Contract #: 04-0120F4Cty: SF/ALA Rte: 80 PM: 13.2/13.9File #: 69.25B**QUALITY ASSURANCE -- NON-CONFORMANCE REPORT****Location:** Changxing Island, Shanghai, P.R. China**Report No:** NCR-000673**Prime Contractor:** American Bridge/Fluor Enterprises, a JV**Date:** 04-Feb-2010**Submitting Contractor:** Zhenhua Port Machinery Company, Ltd (ZPMC), Changxing Island**NCR #:** ZPMC-0641**Type of problem:****Welding****Concrete****Other****Welding****Curing****Procedural****Bridge No:** 34-0006**Joint fit-up****Coating****Other****Component:** Lift 6 West Floorbeam**Procedural****Procedural****Description:** Floorbeam Web Panel- Out of required Flatness**Reference Description:** Lift 6 West Floorbeam Web Plates exceeded the "flatness of panels" requirement**Description of Non-Conformance:**

QUALITY ASSURANCE -- NON-CONFORMANCE REPORT

Contract #: 04-0120F4Cty: SF/ALA Rte: 80 PM: 13.2/13.9File #: xx.25A**QUALITY ASSURANCE -- NON-CONFORMANCE RESOLUTION****Location:** Changxing Island, Shanghai, P.R. China**Report No:** NCS-000770**Prime Contractor:** American Bridge/Fluor Enterprises, a JV**Date:** 19-Mar-2010**Submitting Contractor:** Zhenhua Port Machinery Company, Ltd (ZPMC), Changxing Is

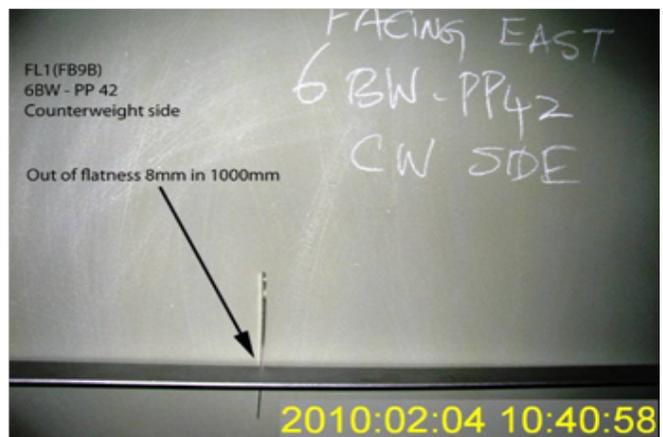
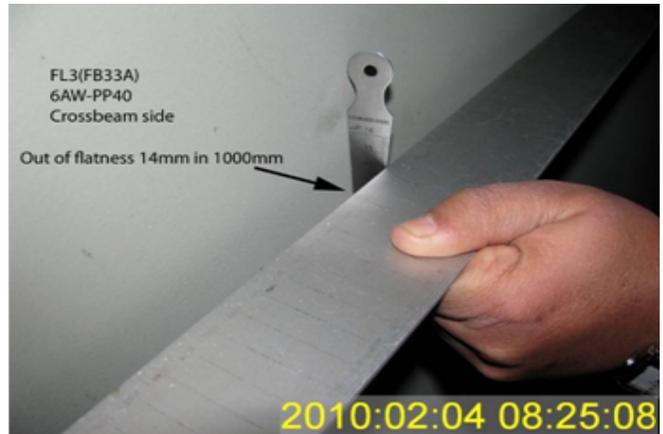
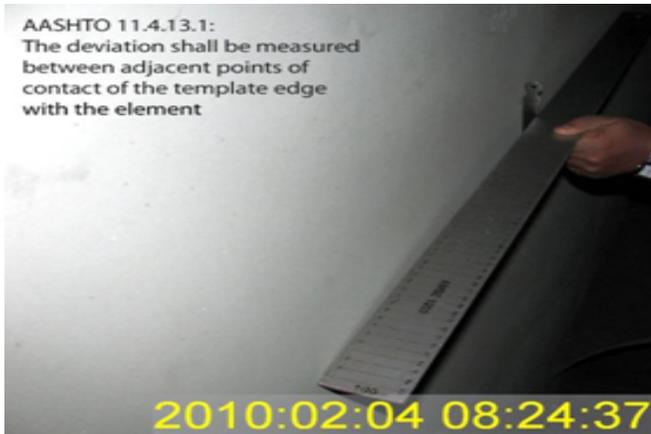
During the Quality Assurance (QA) random in-process visual inspection of OBG Lift 6 West in the OBG Trial Assembly area, this QA inspector discovered the Floorbeam Web Plates exceeded the "flatness of panels" requirements at the following Segments and Panel Points:

OBG Segment 6AW:

PP 38 Counterweight side; The FL1 floor beam FB11B; Deflection 6.5mm over 1000mm

PP 40 Crossbeam side; The FL3 floor beam FB33A; Deflection 14mm over 1000mm

OBG Segment 6BW:

PP 42 Crossbeam side; The FL1 floor beam FB15A; Deflection 6.5mm over 1000mm

PP 42 Counterweight side; The FL1 floor beam FB9B; Deflection 8mm over 1000mm

PP 43 Crossbeam side; The FL1 floor beam FB15A; Deflection 7mm over 1000mm

PP 43 Counterweight side; The FL1 floor beam FB9A; Deflection 7mm over 1000mm

OBG Segment 6CW:

PP 44 Crossbeam side; The FL3 floor beam FB35A; Deflection 13mm over 1000mm

PP 45 Crossbeam side; The FL3 floor beam FB31A; Deflection 10mm over 1000mm

PP 46 Crossbeam side; The FL3 floor beam FB27A; Deflection 7mm over 1000mm

-All the measurements were taken from below the upper Flange plate.

-The maximum out of flatness tolerance allowed per AASHTO 11.4.13.2 requirement is 5mm.

Perform necessary retrofit.
